Addendum

Subject: Addendum to Agenda Item 6b: Annexation ANX 22-02 Marion Pointe

RE: Marion Pointe Application, Woodburn Case Files ANX 22-02, ZC 22-02, PLA 22-02, PUD 22-02, RCWOD 22-01, SUB 22-03 (the "Application")

Date: 6/23/2022
To: Colin Cortes, AICP, CNU-A, Senior Planner – City of Woodburn
From: Rand Waltz/Vu Nguyen, PE
Project Name: Marion Pointe PUD
AKS Job No.: 7564
Subject: Condition of Approval – PUD-PW

**PRELIMINARY OVERALL
 COMPOSITE UTILITY PLAN
 MARION POINTE
 WOODBURN, OREGON**

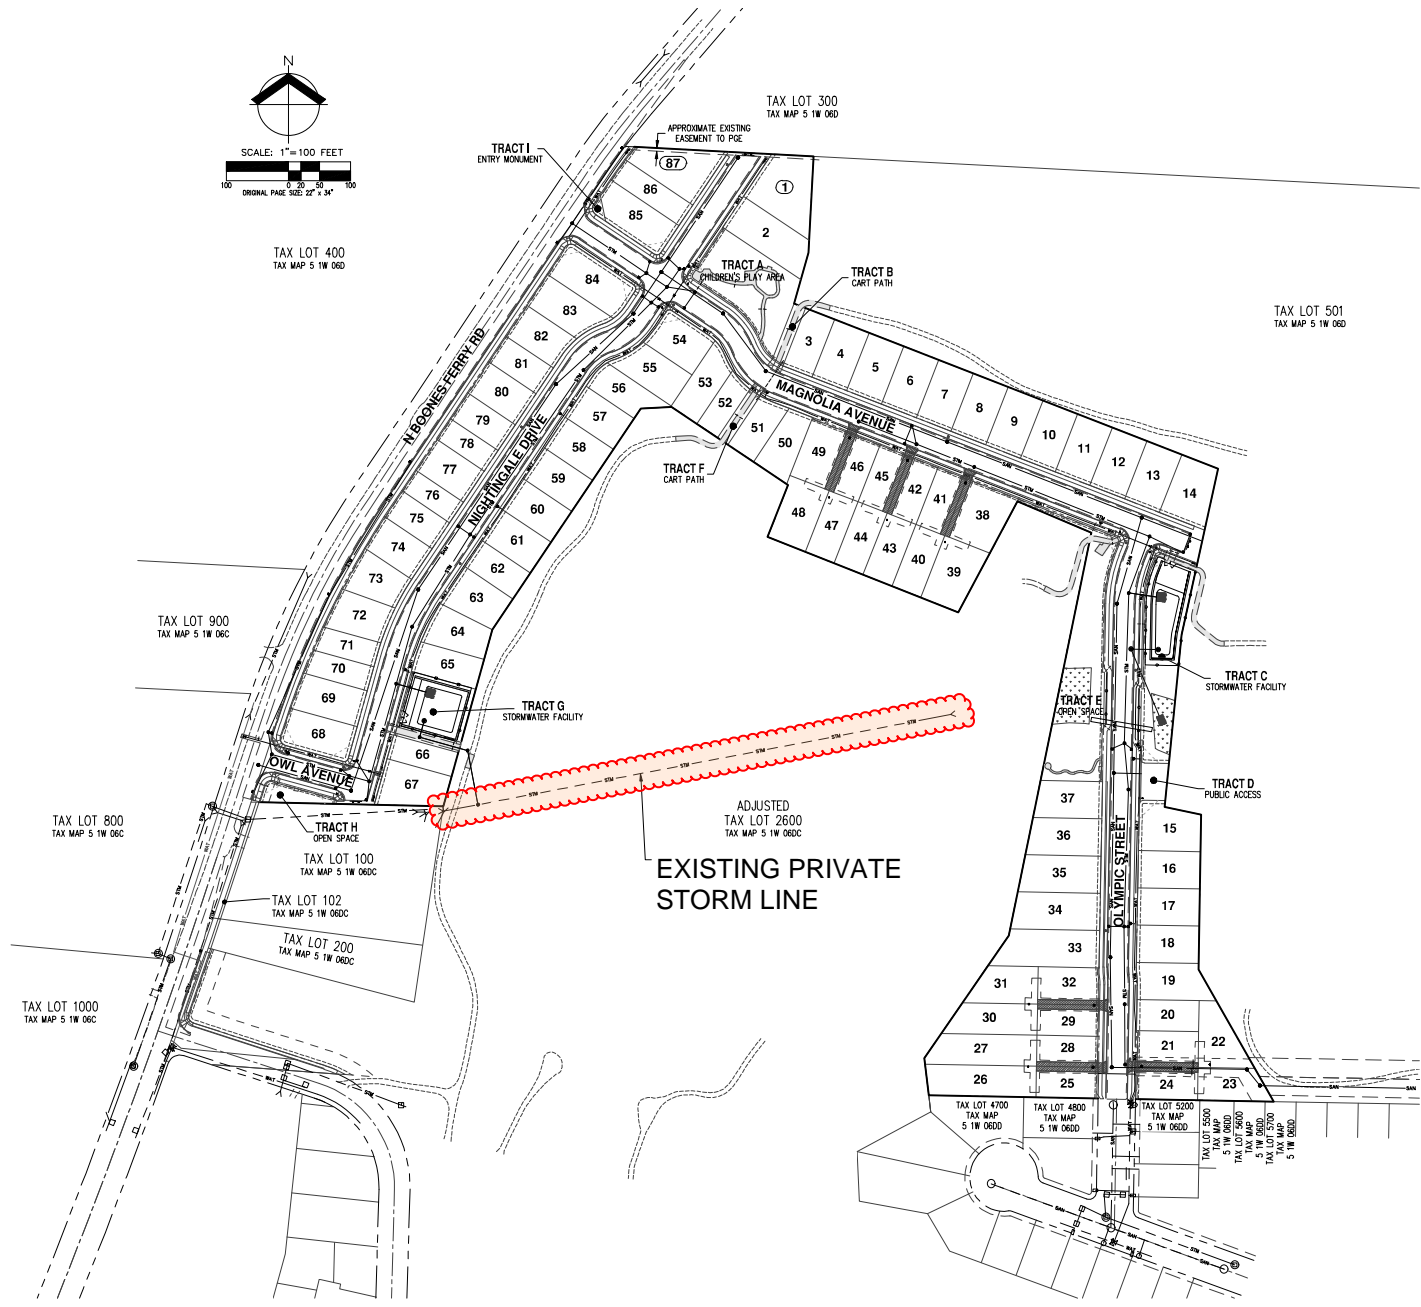
This condition of approval requests that the Marion Pointe project increase the capacity of an existing offsite private stormwater main pipe to accommodate flows beyond normal City standards for this project and an offsite residential development project (Dove Landing). Additionally, construction of this main pipe will require a public storm drainage and temporary grading and construction easement on private property that is not owned or controlled by the applicant. There is no certainty that the easement required for construction will be granted by the offsite property owner.

The existing 24-inch culvert under the future Olympic Street will be replaced with a 72-inch diameter culvert. This new culvert will be sized to accommodate stormwater runoff from this site and the upstream basins (including Dove Landing under fully developed conditions) based on peak flows for the 100-year storm event.

In larger storm events, stormwater could back up out of offsite private stormwater main pipe and sheet flow across the golf course property; however, this is the historical route of the stormwater runoff, and there are no structures in this flow path.

Since this project meets the City's Storm Drainage Master Plan detention and conveyance standards and because of the proposed Olympic Street culvert replacement, there are no downstream conveyance deficiencies. Because of this, condition of approval PUD-PW should not be applied to this project.

Exhibit PUD-3f: Site Plan Sheet P-26 Sidewalks (blue: min 8 ft wide); see Attachment 103 for full size

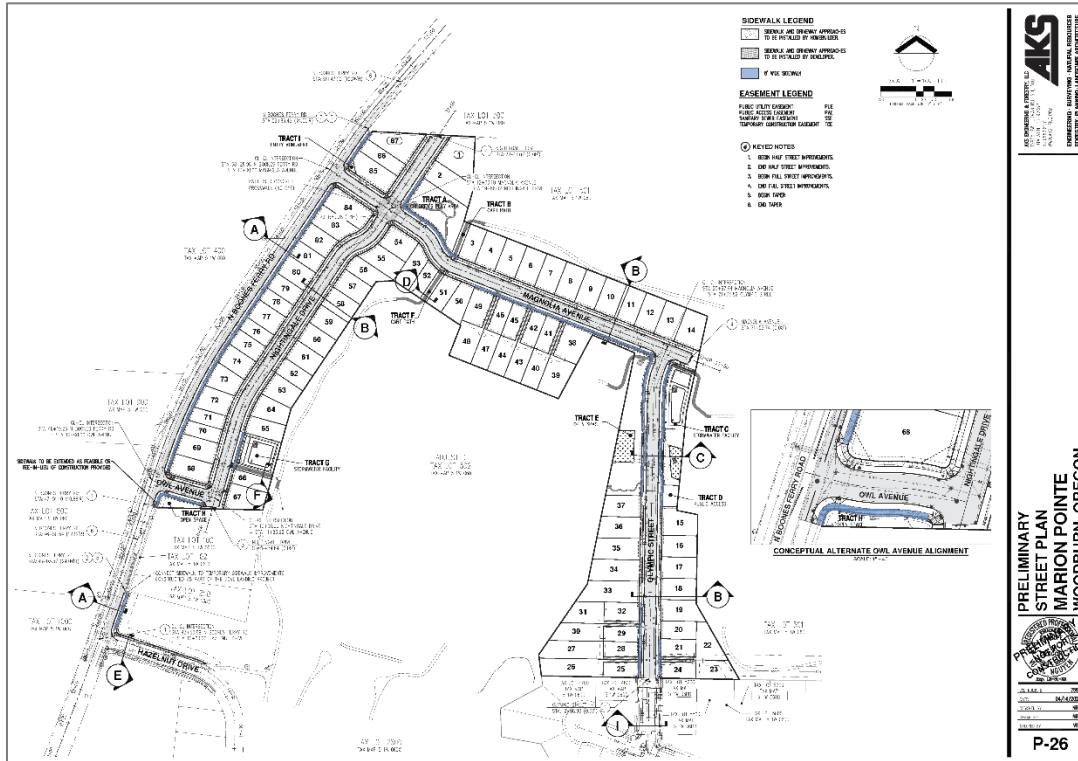
- f. Sidewalks: Min 6 ft wide except wider as Exhibit PUD-3f supersedes. BFR sidewalk southerly and two northerly dead-ends shall have ADA-compliant transitions spanning between sidewalk and road shoulder as the applicable public works authority specifies. The segment extending north from Hazelnut sidewalk may meander, including PUE

overlap, and taper to 6 ft through RPZs to save most of the loose row of trees along the road.
